COLORADO DI vISION OF RECLAMATION, MINING AND SAFETY MINERALS PROGRAM INSPECTION REPORT

MINE NAME:	MINE/PROSPECTING ID#:	MINERAL:	COUNTY:
Lily Mines	M-1987-028	Marble	Chaffee
INSPECTION TYPE:	INSPECTOR(S):	INSP. DATE:	INSP. TIME:
Monitoring	Dustin M. Czapla	September 10, 2014	12:30
OPERATOR:	OPERATOR REPRESENTATIVE:	TYPE OF OPERATION:	
Monarch Mountain Minerals and Aggregates,	None	112c - Construction Regular Operation

Figure 5: South highwall area

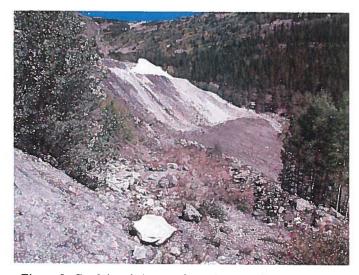
The east facing highwall spans approximately 1,000 linear feet up to heights of 40-60 feet. A condition of the permit requires the operator to include a report describing geotechnical conditions related to construction of the highwalls with their annual report each year. A review of the permit file found that this condition has not been complied with. This has been noted as a problem.

CORRECTIVE ACTIONS: Submit the required geotechnical reporting information.
